ADDENDUM NO. 1

This **Addendum No. 1** gives additional information in connection with **Contract No. T-644A, Capital Project 1323A, I-78 Bridges and Approach Slab Rehabilitation** and is hereby made a part of the Contract. This Addendum is to be signed by the Contractor below and this **Page AD1-1** is to be attached to the bid proposal.

**CONTRACT NO. T-644A, CAPITAL PROJECT 1323A  
I-78 BRIDGES AND APPROACH SLABS REHABILITATION**

PRECAST APPROACH SLABS DETAILS - 2

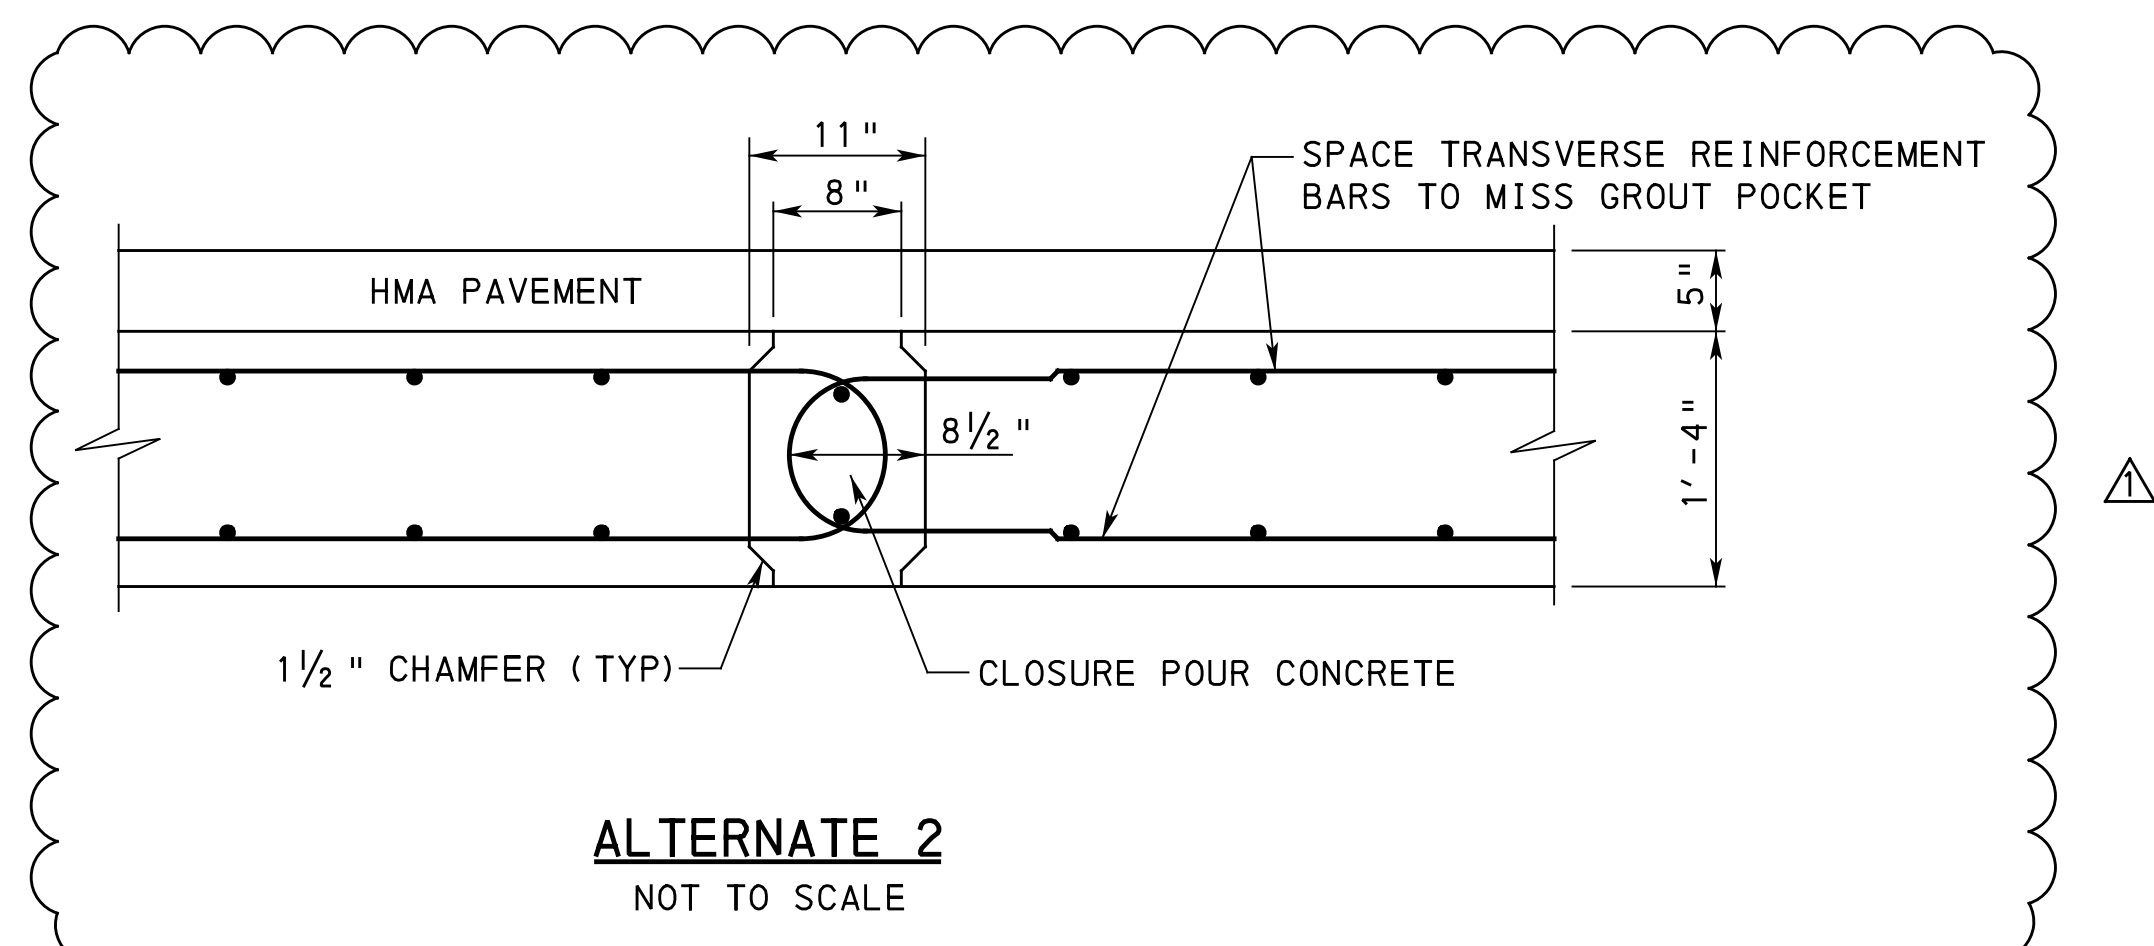
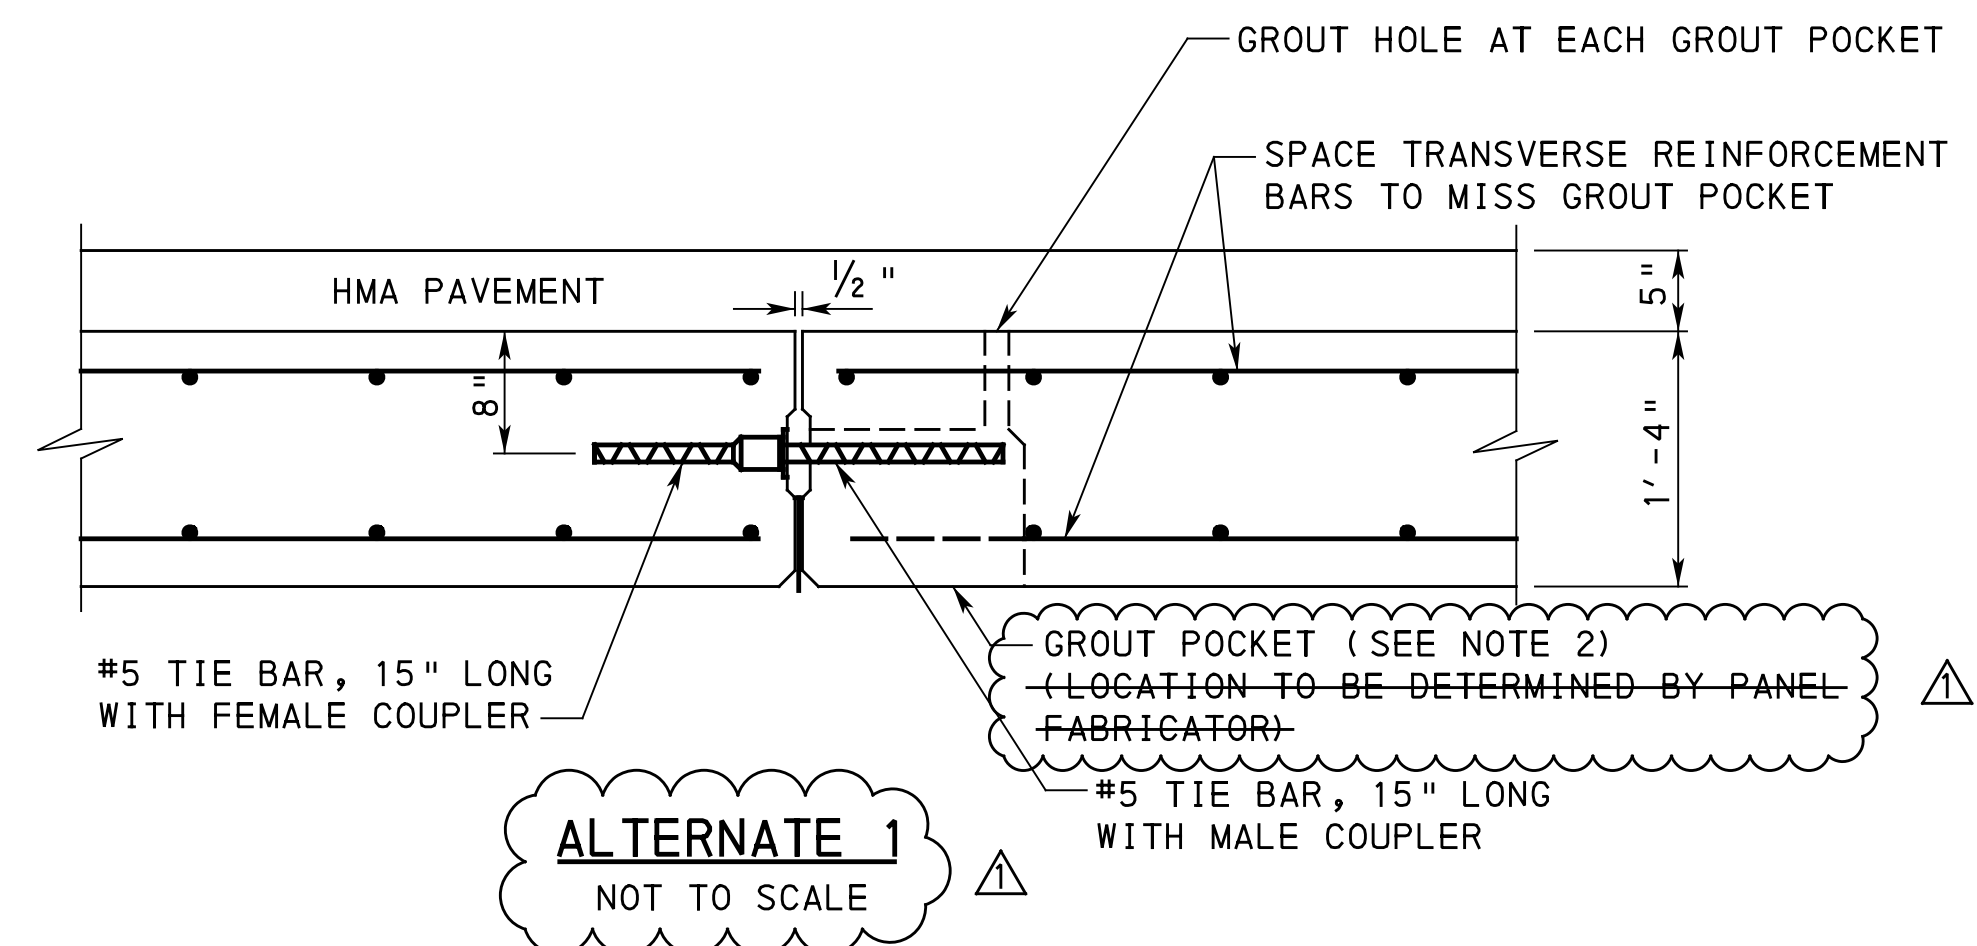
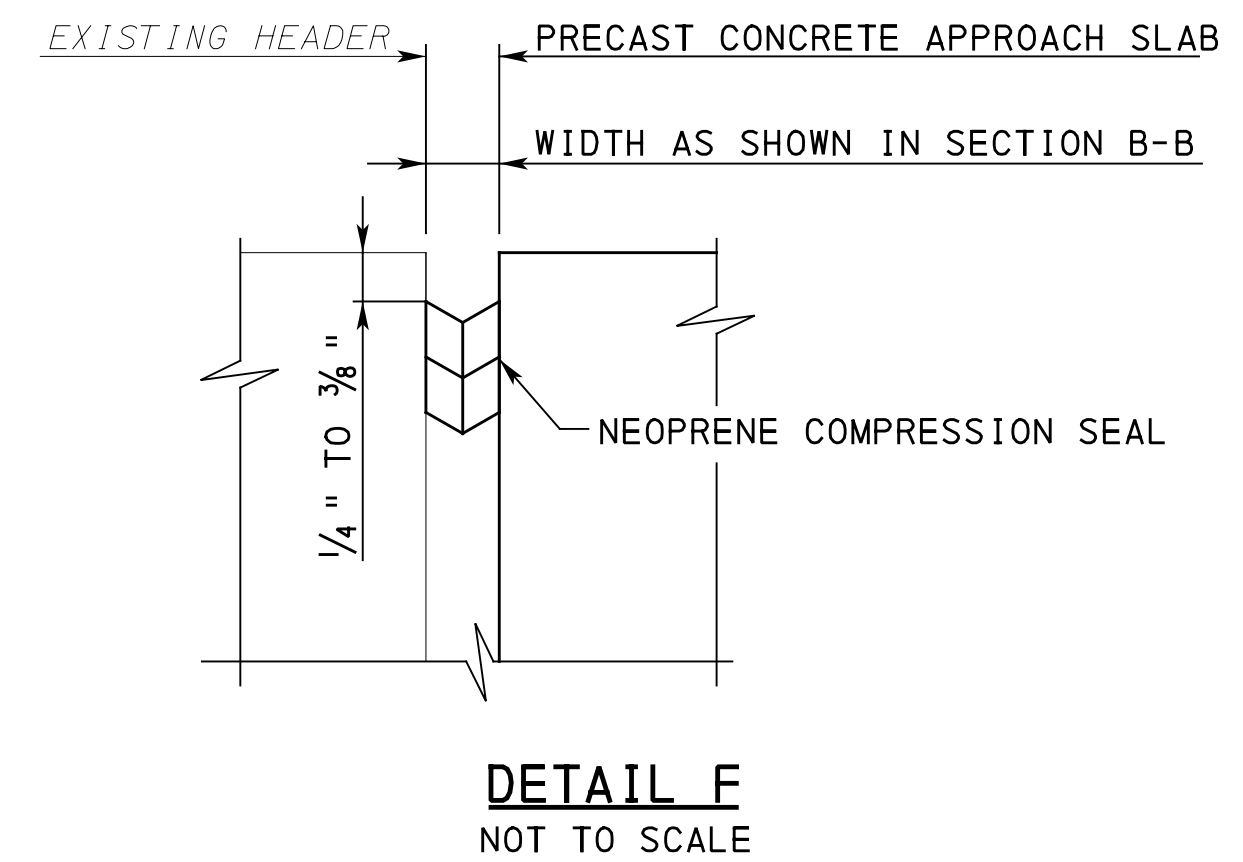
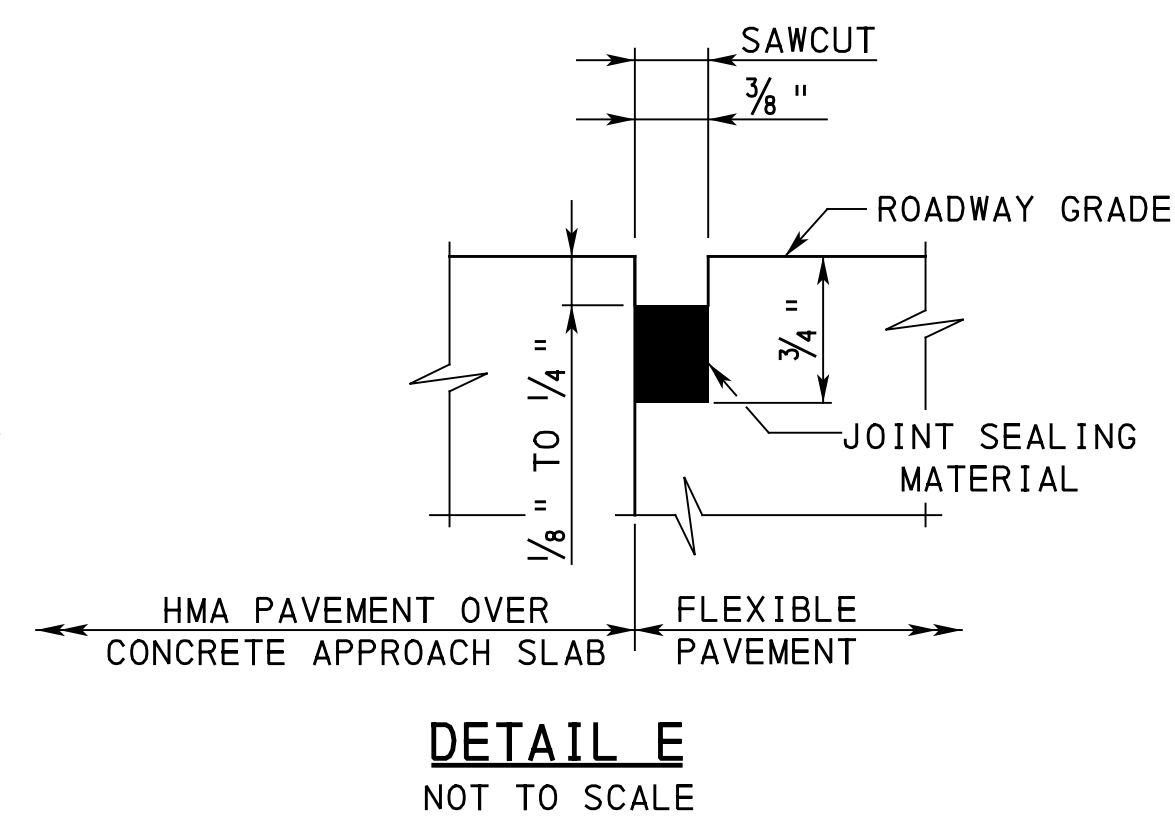
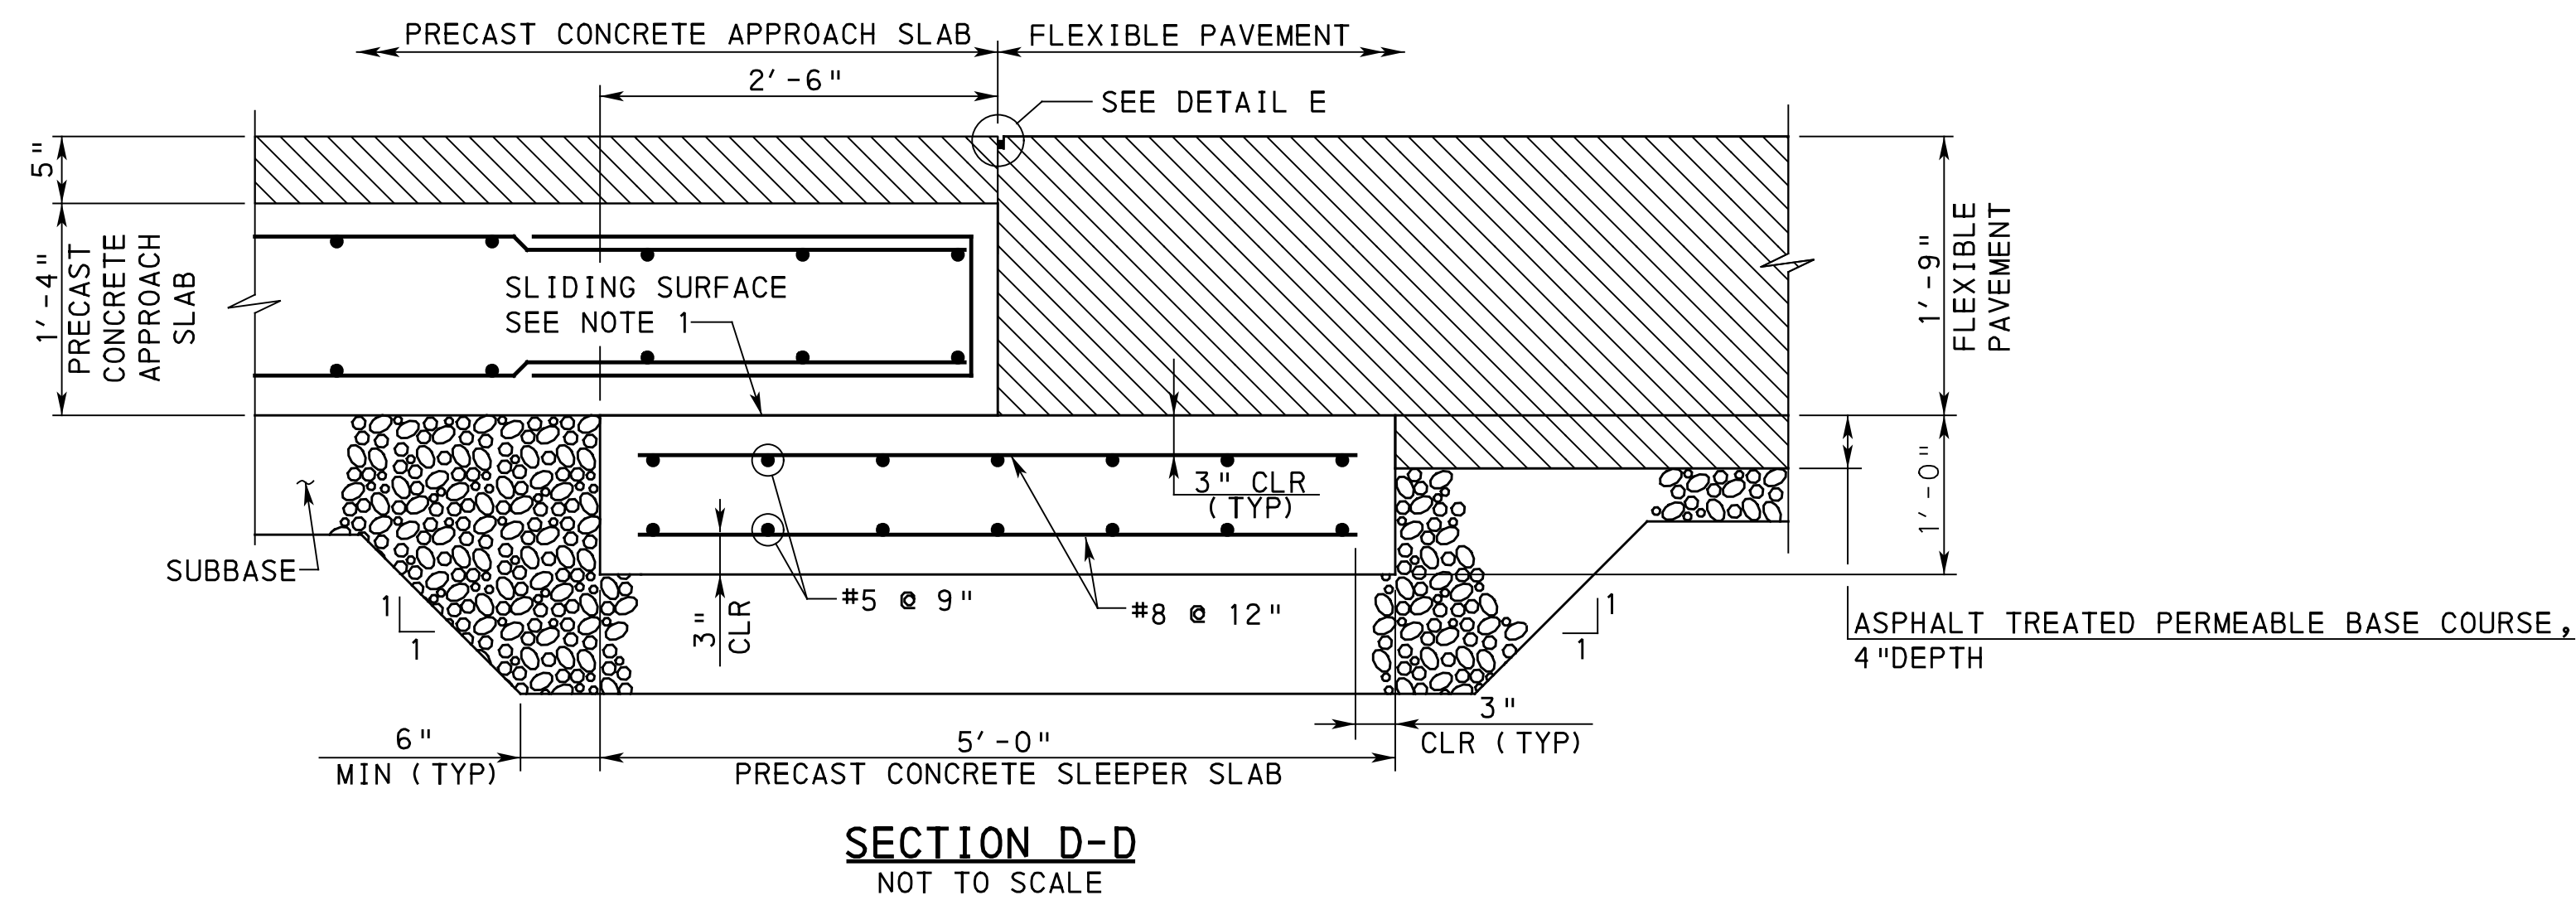
1. Replace PLAN sheet No. 95 (**BP-21**) with Plan sheet No. **95R, BP-21, AD1-8** attached.
